APPLICATION NO: 16/01337/FUL		OFFICER: Mr Ben Hawkes
DATE REGISTERED: 27th July 2016		DATE OF EXPIRY : 21st September 2016
WARD: Charlton Park		PARISH:
APPLICANT:	Mr Andrew Yapp	
LOCATION:	1 College Gate, Cheltenham	
PROPOSAL:	Erection of double garage (resubmission of application 13/00127/FUL)

Reference 16/01337/FUL - 1 College Gate

Comments following Applicant's submission of revised plan and additional information

TITLE
**PROPOSED PLAN &
ELEVATIONS**
SITE PLAN & BLOCK PLAN
SCALE 1:500 & 1:100

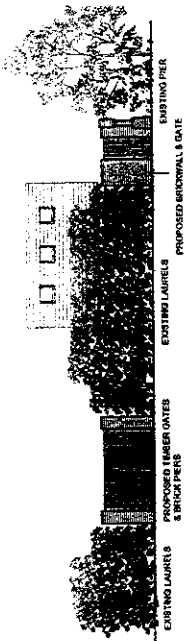
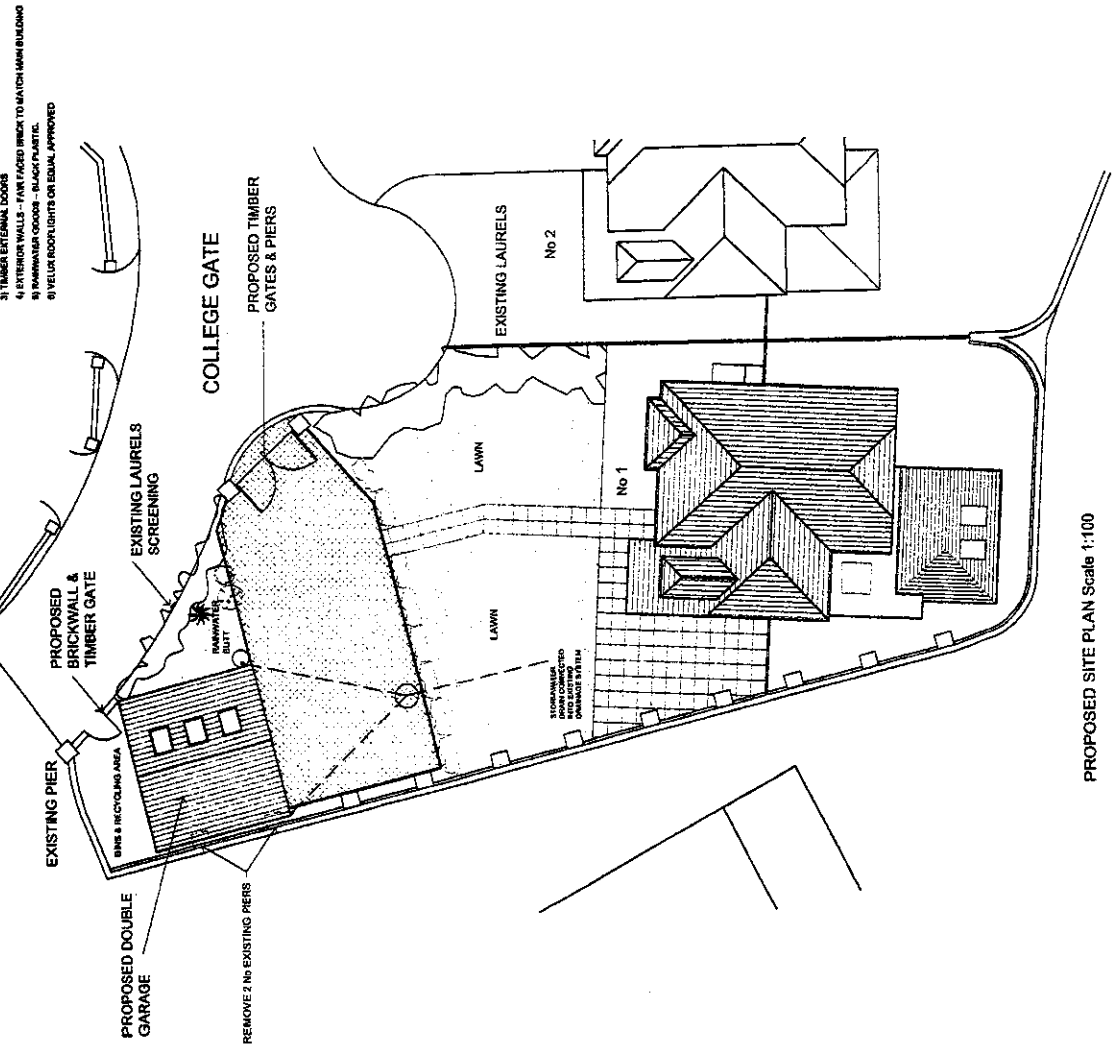
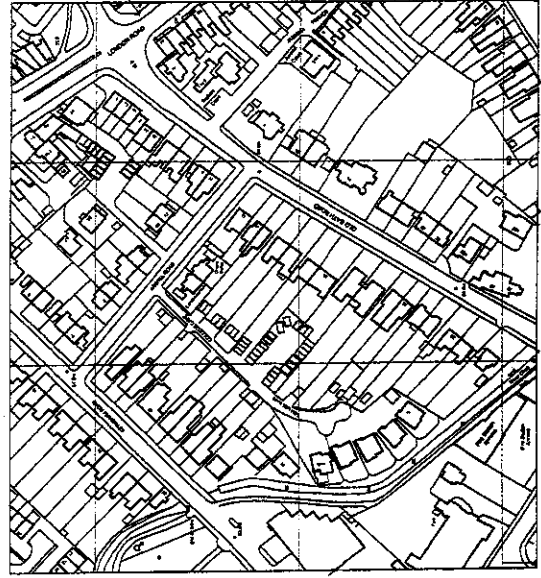
22. Of greater concern is the substantial extension to 1 College Gate, which was shown on only a single occasion by the Applicant (**Enc 1**) but has now been deleted from the revised plan (**Enc 2**). The extension impedes flood flows into the open manhole next to the rear extension, in breach of the last paragraph of page 1 of **Enc 6**. The absence of the extension and manhole cover in most of the plans for both the 2013 and 2016 Schemes is therefore very misleading.

CURRENT APPLICATION 16/01337/PUL

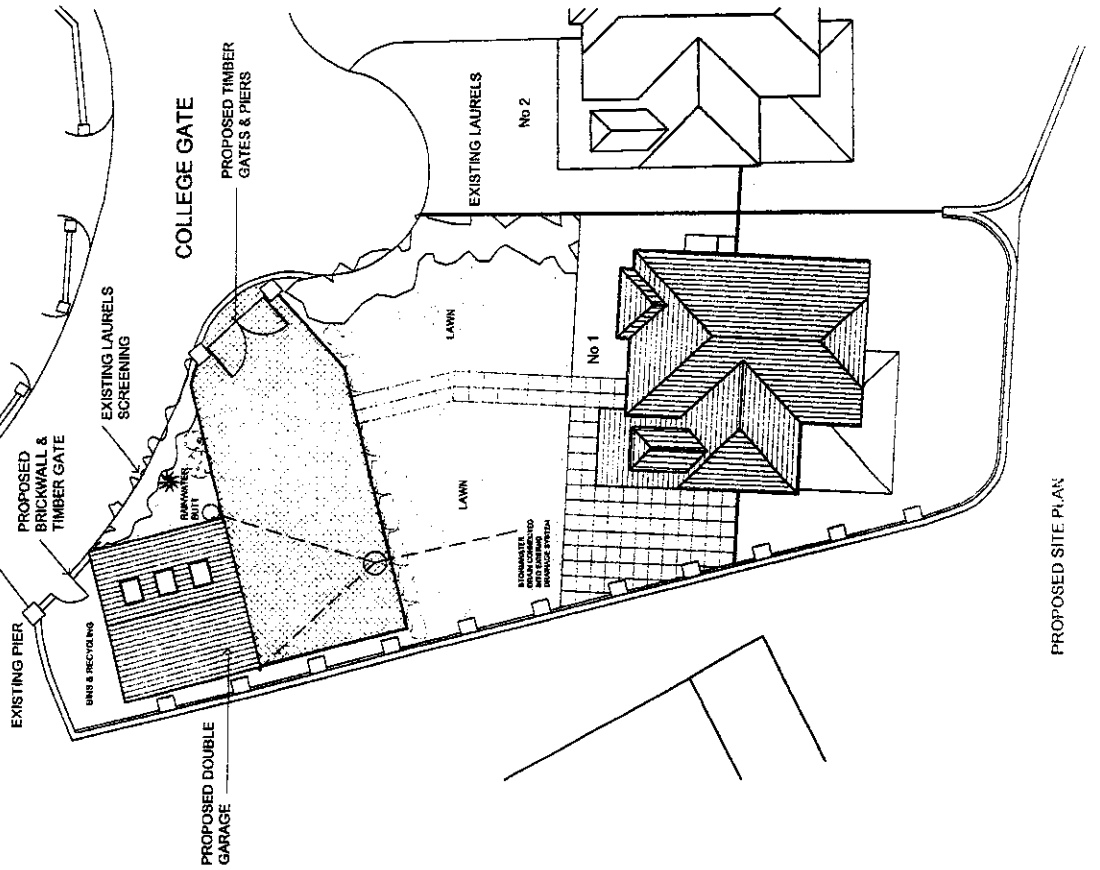
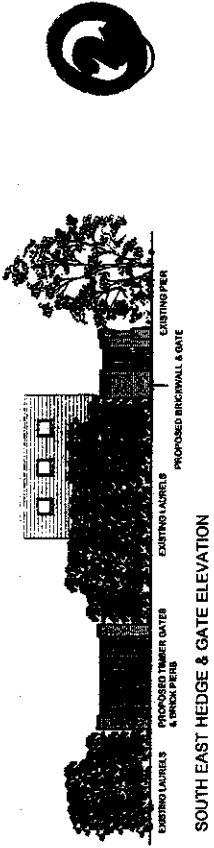
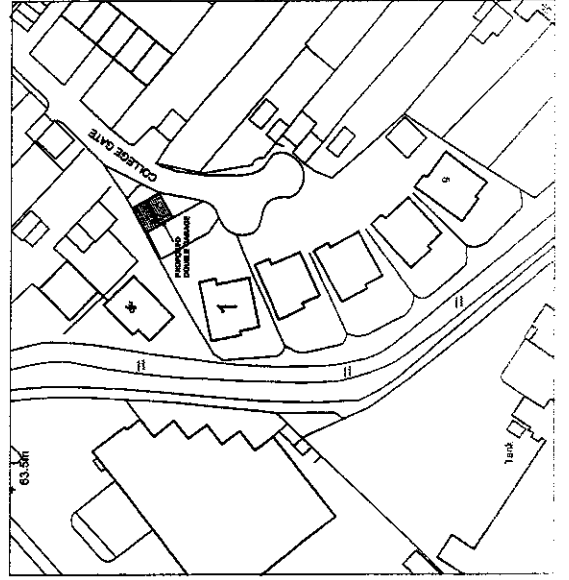
19. I would suggest that the RSA plan is completely misleading; not only has the substantial rear extension been removed, it illustrates a greater distance from the rear of the property to the “collection chamber”. It is in fact not a collection chamber, but an open manhole cover to accept surface water flows.
